**102 Seventh Avenue
Applicant-led Public Consultation – Response to concerns**

31 January 2022

PROJECT : 19-011
 HRA RESTORATION AND DUPLEX
 102 SEVENTH AVENUE
 NEW WESTMINSTER, BC'

DWG TITLE: GARBAGE LAYOUT

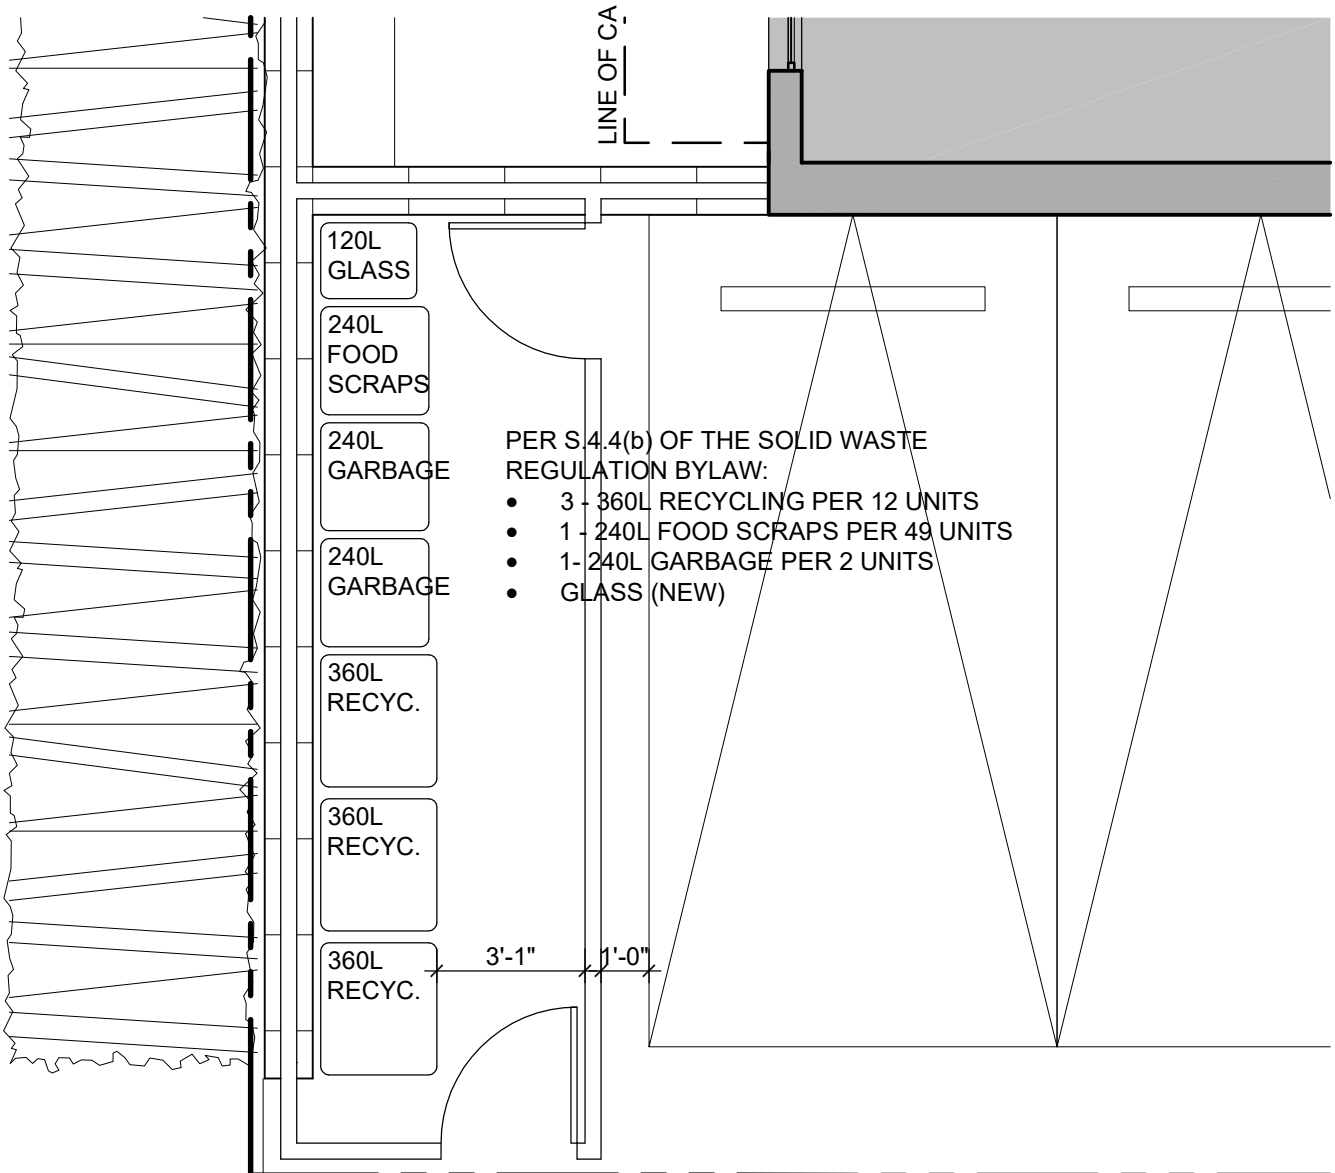
Garbage

This property will be serviced as a multiple residential complex for garbage/recycling/organics with one central storage area. It will include the following bins per S.4.4(b) of the solid waste regulation bylaw:

- 3 - 360L recycling per 12 units;
- 1 - 240L food scraps per 49 units;
- 1- 240L garbage per 2 units;
- 1-glass (new);

The required bins are accommodated within a closed fence, screened from view as required by Zoning Bylaw General Regulation 190.51, see attached drawing of Garbage Layout.

102 - 7th Street
Backup Clearance
Swept Path Analysis

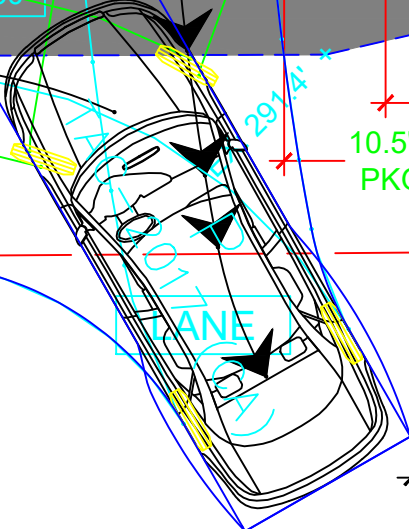
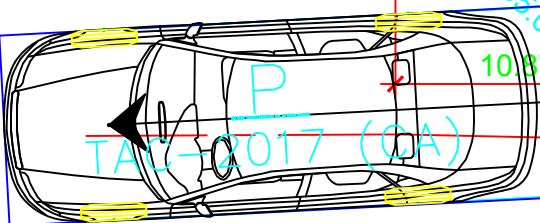
Traffic / Parking

Creative Transportation Solutions Ltd. (CTS) undertook a swept path analysis for a passenger car reversing out from the most easterly parking space at the rear of 102 – 7th Avenue in the City of New Westminster. Upon reversing out from the parking space the passenger car was assumed to travel south along the lane. See **FIGURE 1** attached. As demonstrated by the analysis, the passenger car is able to make the turn while maintaining a distance of 12' 6" from the pedestrian crossing on 1st Street.

CTS would also note that the passenger car is most likely to reverse out away from the pedestrian crossing and travel north along the lane, the shortest distance to an intersecting road.
